**Lee Nuclear Station Units 1 and 2
Description, Scope of Changes, and FSAR Impacts due to Plant Relocation and
Additional Design Enhancements**

**Description and Rationale for Lee Nuclear Station Units 1 and 2 Relocation and
Additional Design Enhancements**

FIGURE 2.4.5-202

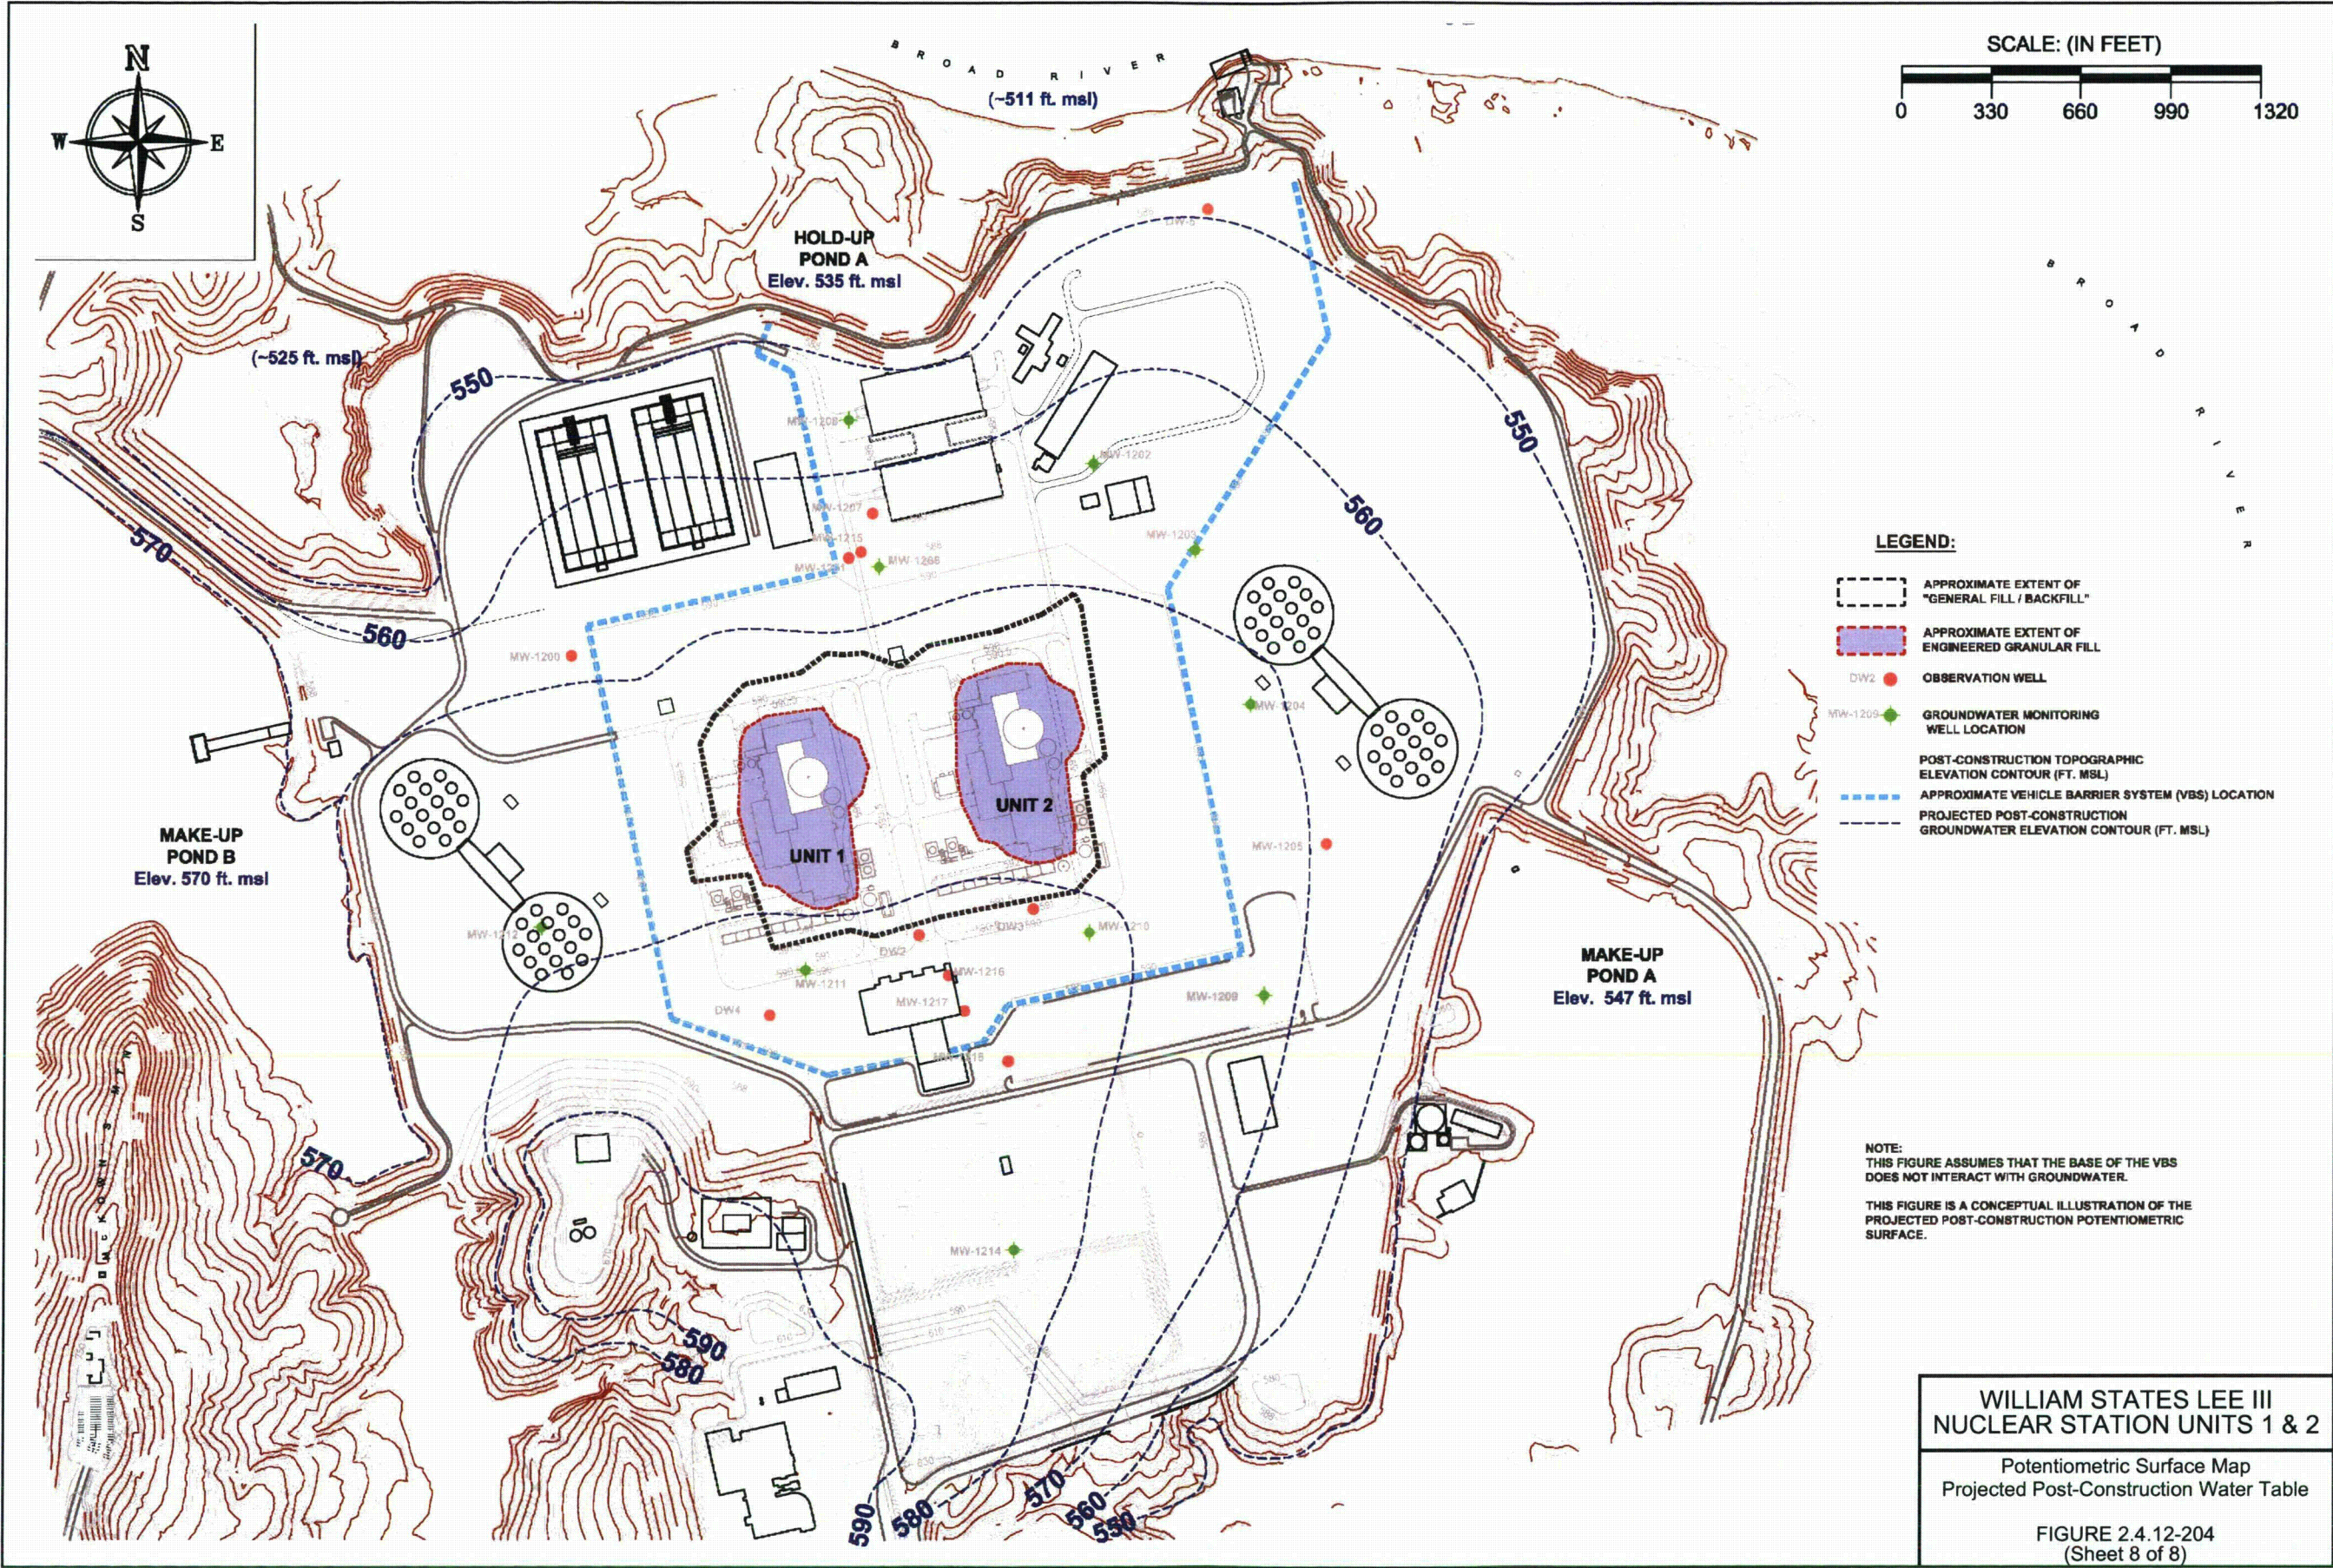
Make-Up Pond B surge flooding is evaluated coincident with the 100-yr. water surface elevation of ~~576.22~~ 576.18 ft. The critical fetch length is ~~4.30~~ 1.38 mi. as shown in Figure 2.4.5-202. The wind speed is adjusted based on the factors of fetch length, level overland or over water, critical duration, and stability using U.S. Army Corps of Engineers guidance (Reference 295). The critical duration is ~~26~~ 28 min. The adjusted wind speed is ~~90.489.9~~ 90.489.9 mph.

65. COLA Part 2, FSAR Chapter 2, Figure 2.4.5-202 is revised as follows:

Figure 8.2-202

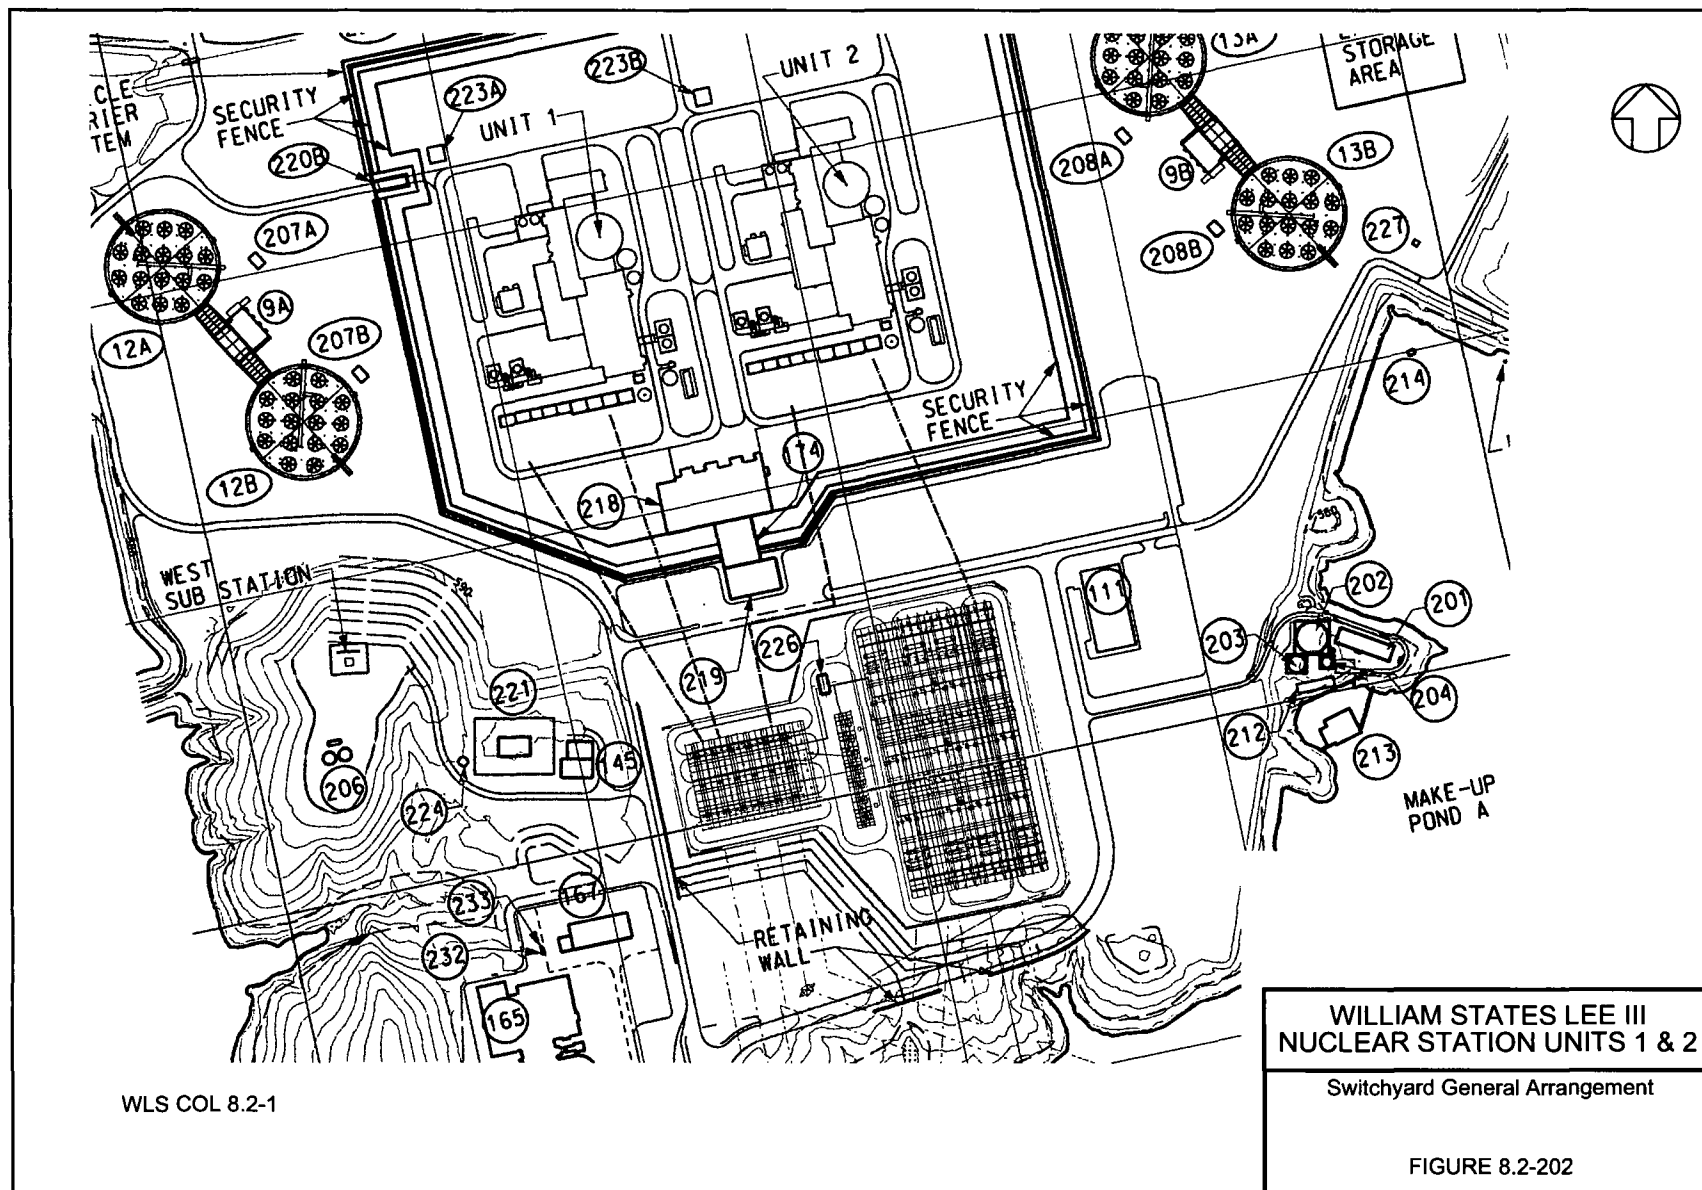
The information provided in FSAR Chapter 8 is limited to the incorporation by reference to the AP1000 DCD and programmatic information that is not dependent on the plant location. However, FSAR Figure 8.2-202 provides a layout depicting orientation of the 230 kV and 525 kV switchyards relative to Lee Units 1 and 2. This figure is revised to incorporate the updated locations of the units.

1. COLA Part 2, FSAR Chapter 8, Figure 8.2-202 is revised as follows:
